# Access Compliance Report

## Public Rights-of-Way

Intersection ID: 30285	Main Street: DERRYFIELD_DR	Cross Street: HAMPTON_WAY_DR	Location: NW
ADA ID: 702B87B771A2	Ramp Type: BlendTrans1	Initial Pass/Fail: Fail	Overall Compliance: No
Severity Score: 10			
Codes/Mitigation Info/Possible Solution		Field Measurements/Component Compliance

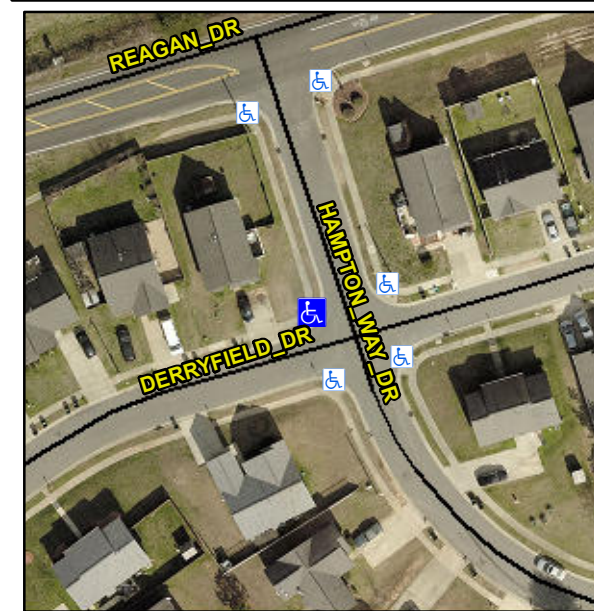
**Remove & Replace Curb Ramp With Two New Directional Ramps or Equivalent.**

**Not Found, R304.5.1, R304.5.3**
